Project Title: Aerovox Remedy Design Build

Subject: Aerovox Year 2 Modifications and Information Transmittal

Date: March 16, 2022

To: New Bedford Conservation Commission

CIVIL
TITLEIST SHORELINE RESTORATION PLANTING PLAN
DRAWING NUMBER
C-205
SHEET NUMBER
14 OF 47

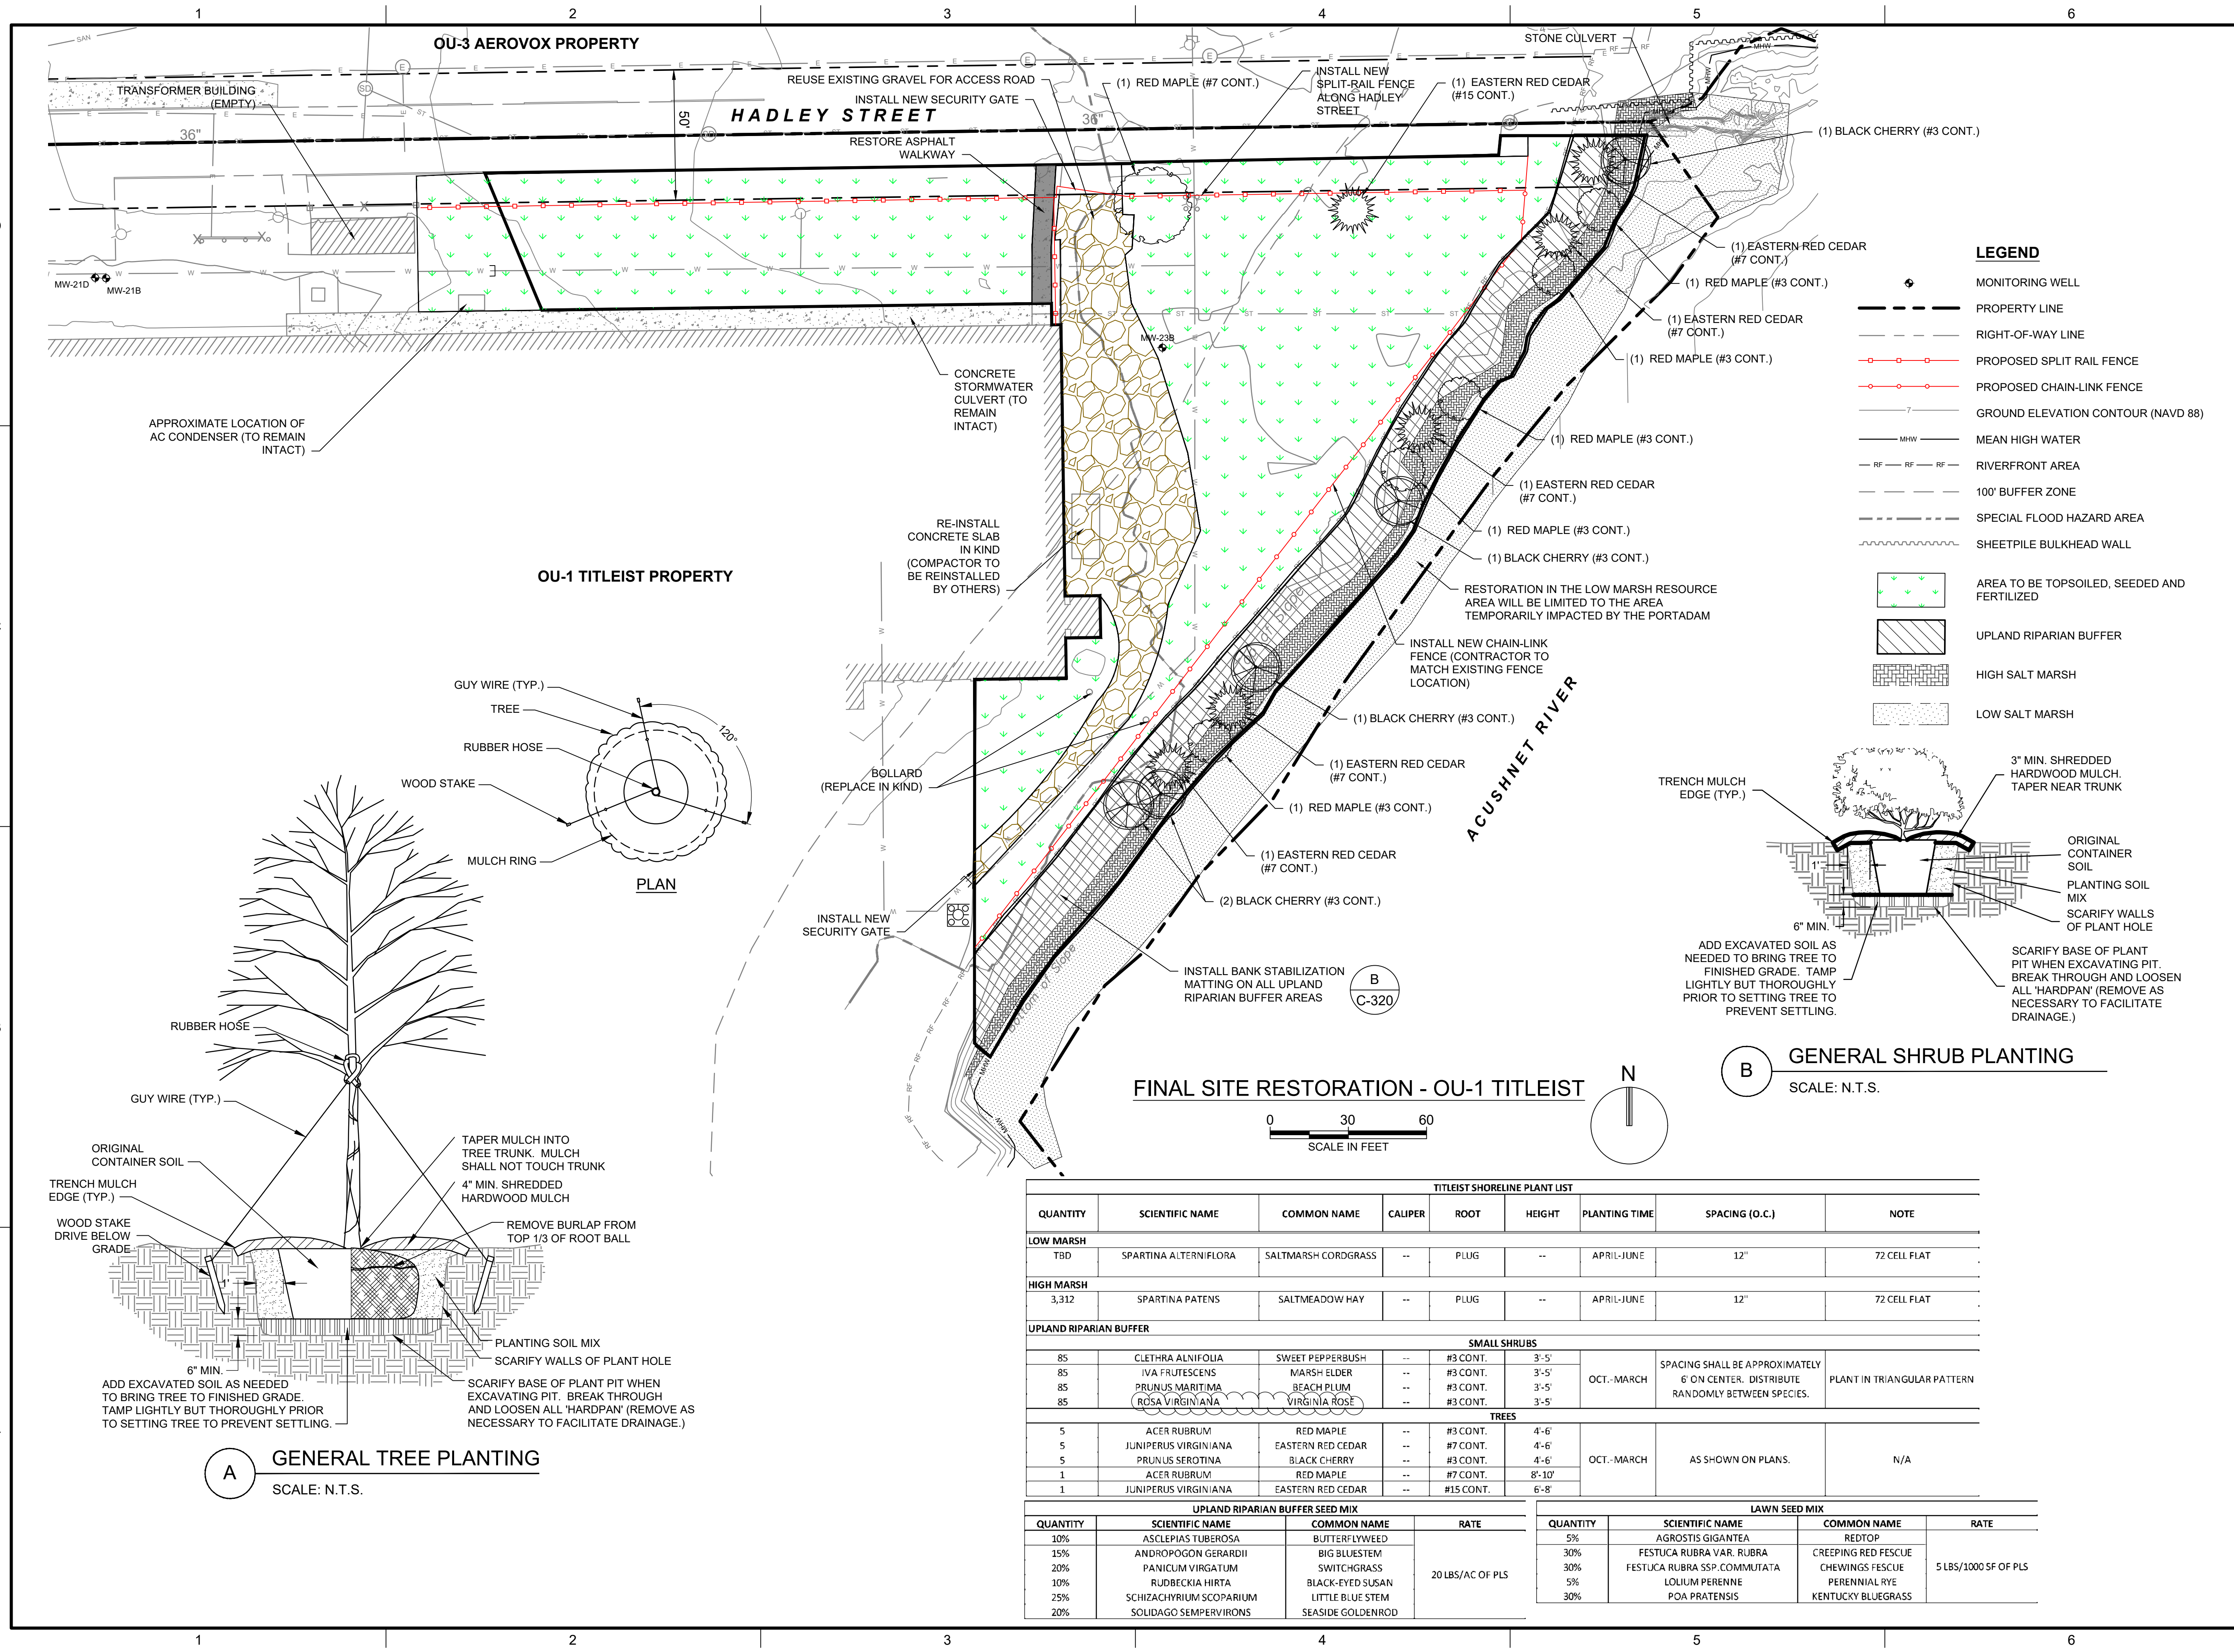
See Attachment B, revision to construction Drawing C-205, for revisions to the planting plan requested by the ACOE as part of their permit approval.

As part of the New England District of the U.S. Army Corps of Engineers (ACOE) review of the Pre-construction Notification for General Permit 17 (Cleanup of Hazardous and Toxic Wastes) for the Aerovox Remedy Implementation, ACOE requested a modification to the planting restoration plan for the Titleist (OU1) work and restoration monitoring. Specifically, ACOE requested that swamp rose (*Rosa palustris*) be replaced by the Virginia Rose (*Rosa virginiana*).

CIVIL
 AEROVOX STORM SEWER MODIFICATIONS PLAN
 DRAWING NUMBER
C-309
 SHEET NUMBER
 24 OF 47

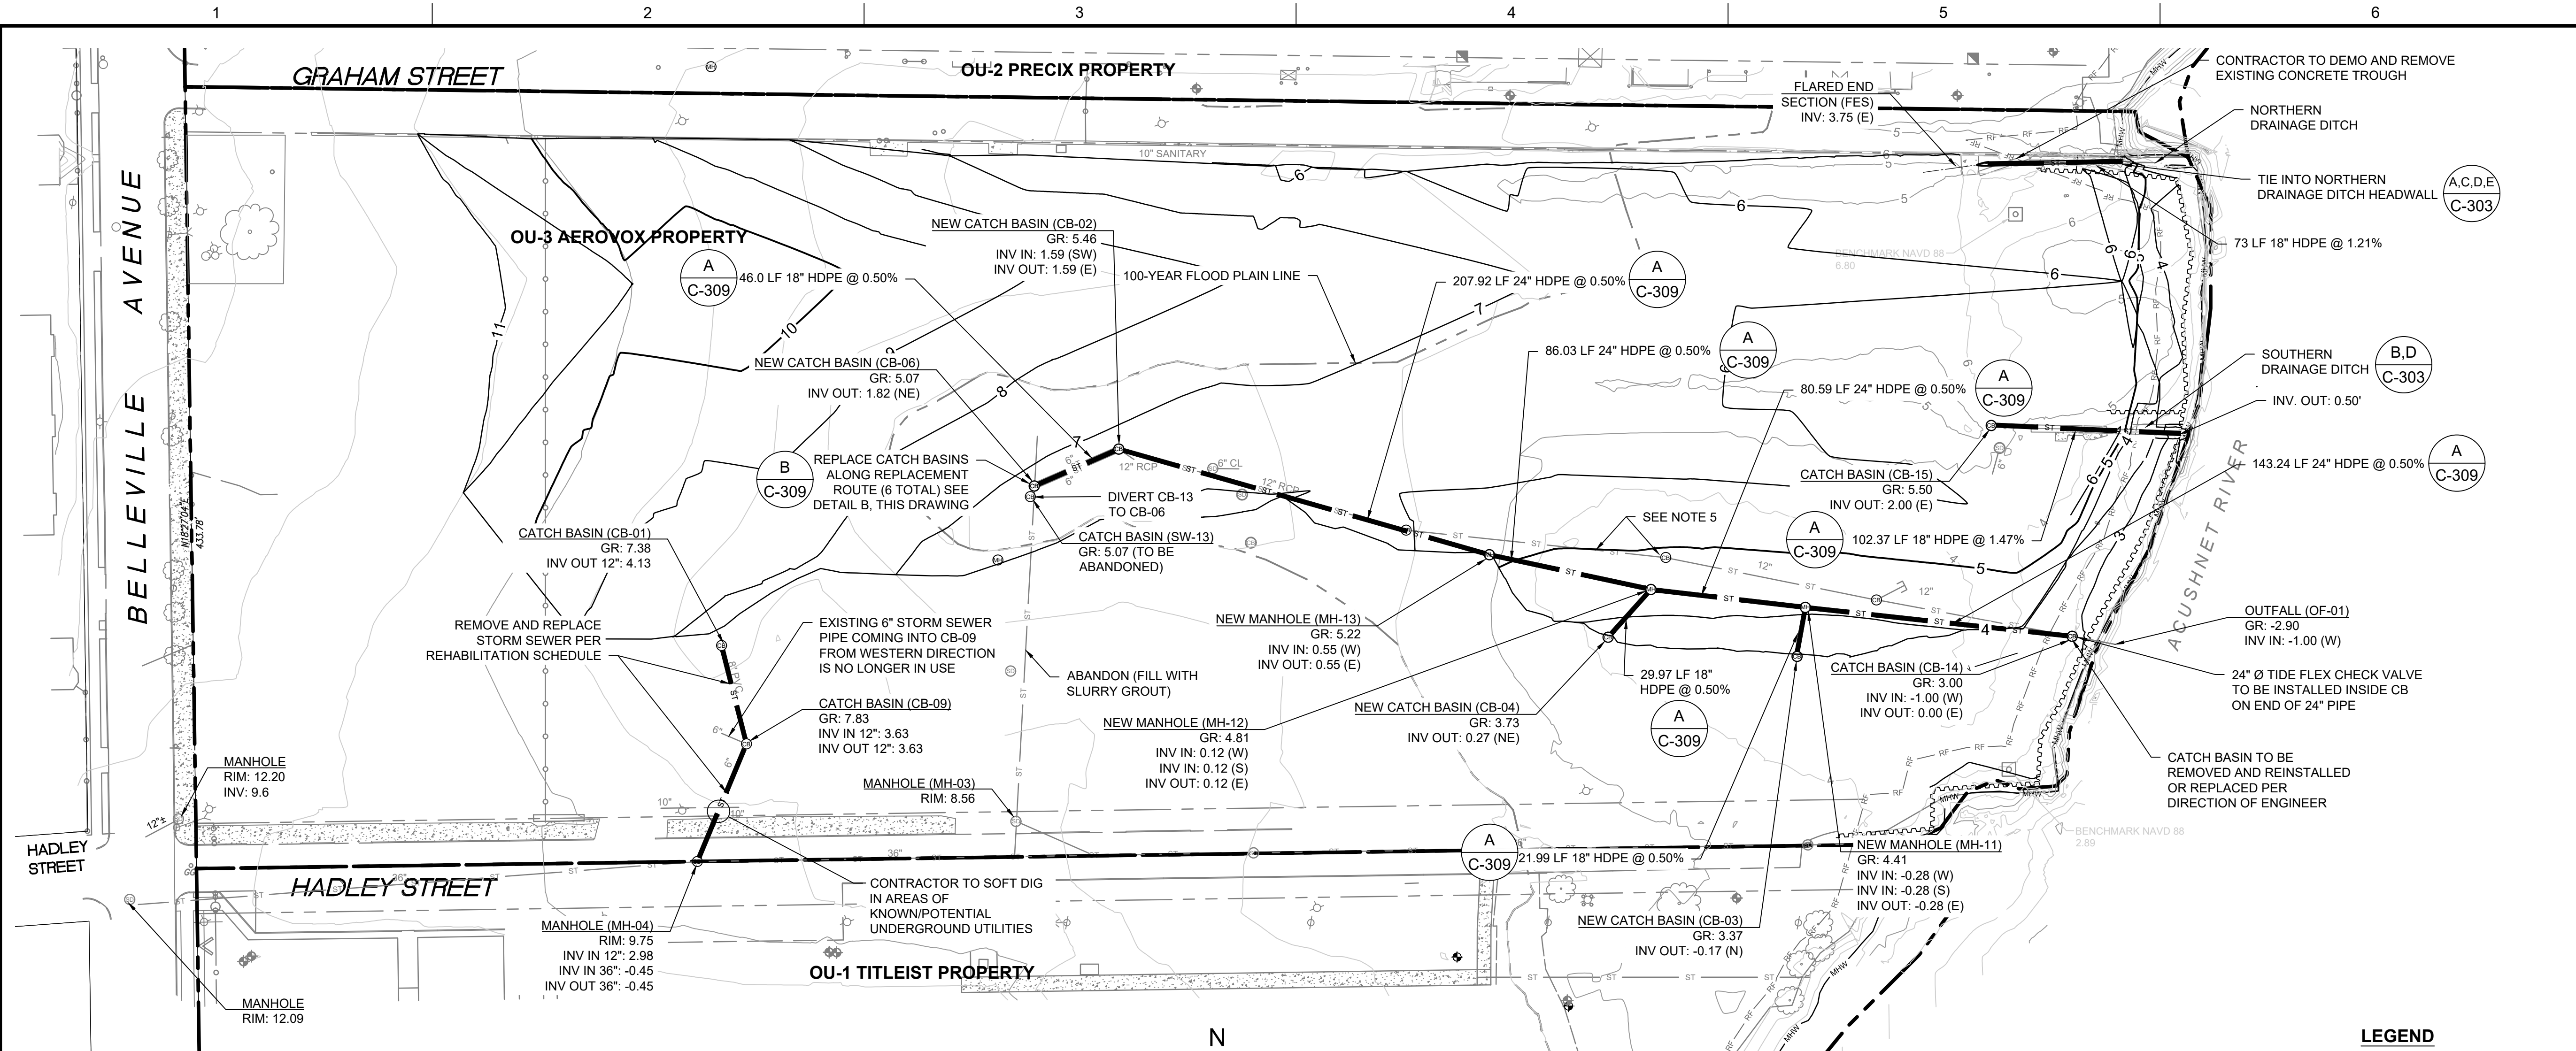
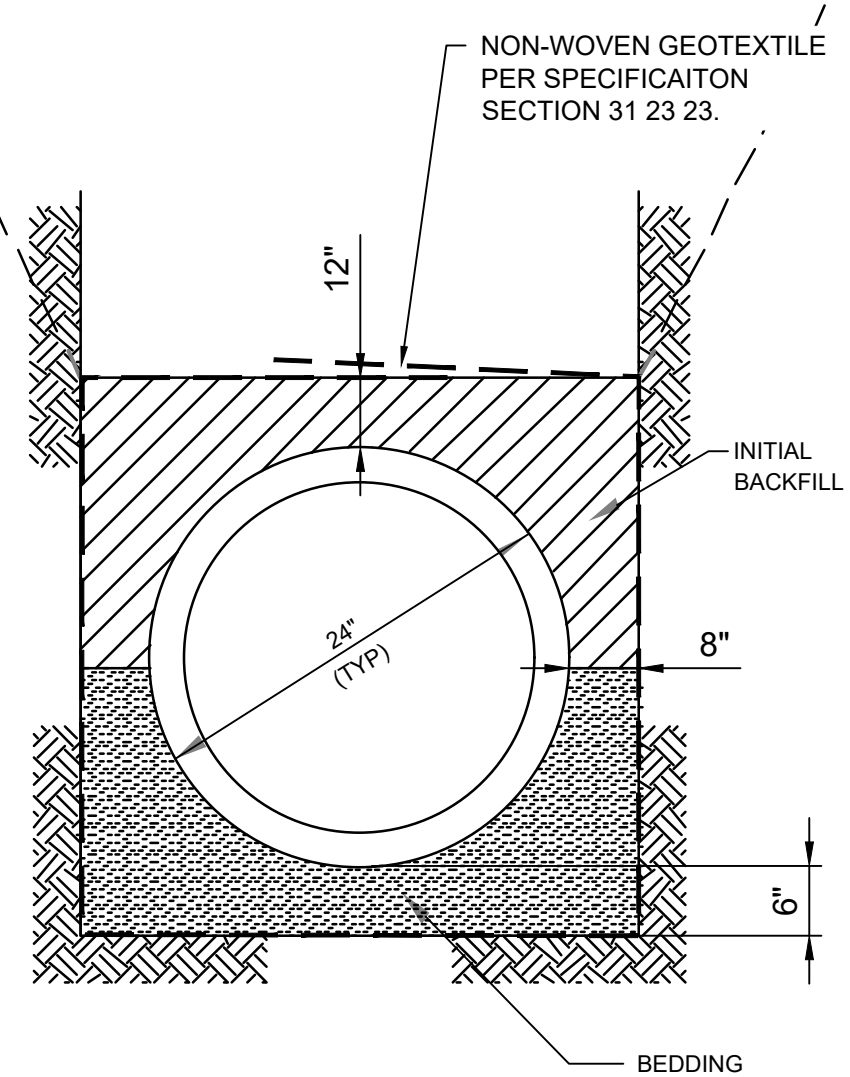
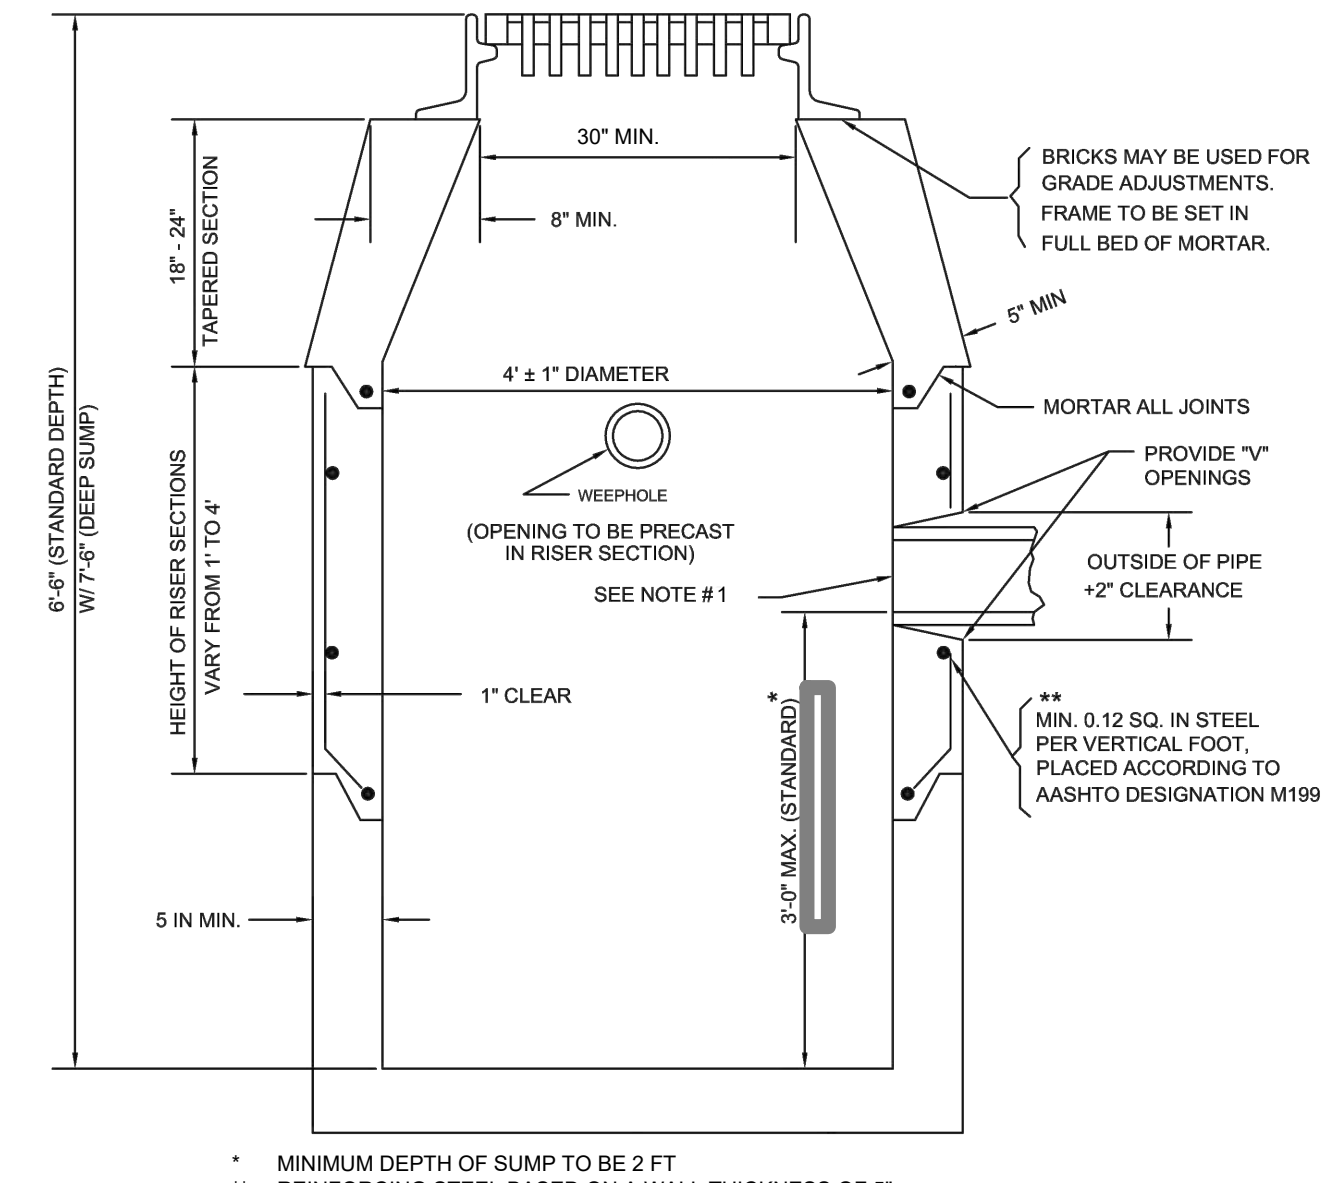
The MCP Phase IV Plan as provided in the NOI included replacement of the majority of the storm sewer lines within the Aerovox property with the exception of the north-south line connecting one manhole and two catch basins to the trunk line in Hadley Street, i.e., the MH-04/CB-01/CB-09 line, which was previously slated to be cleaned and lined. Stormwater sampling data provided by U.S. Environmental Protection Agency (EPA) has subsequently indicated PCB impacts in catch basin CB-09. As such, it is more prudent to replace, rather than line this section.

Stormwater Infrastructure Restoration of the MH-04/CB-01/CB-09 line has been adjusted to removal and replace rather than clean and line. Scope of work to include surveying and utility locating of impacted area, removal of existing infrastructure, including catch basins and manholes, replacement with 12-inch high density polyethylene (HDPE) piping and two new catch basins and one manhole, permitting and regulatory requirements associated with the replacement, and backfill of the trench. Any repairs made to concrete walkway or asphalt within Hadley Street shall be repaired in kind. These revisions are captured in revised Drawing C-309 which has been included in Attachment B.

SEGMENTS MODIFIED TO BE REMOVED AND REPLACED WITH NEW HDPE PIPE
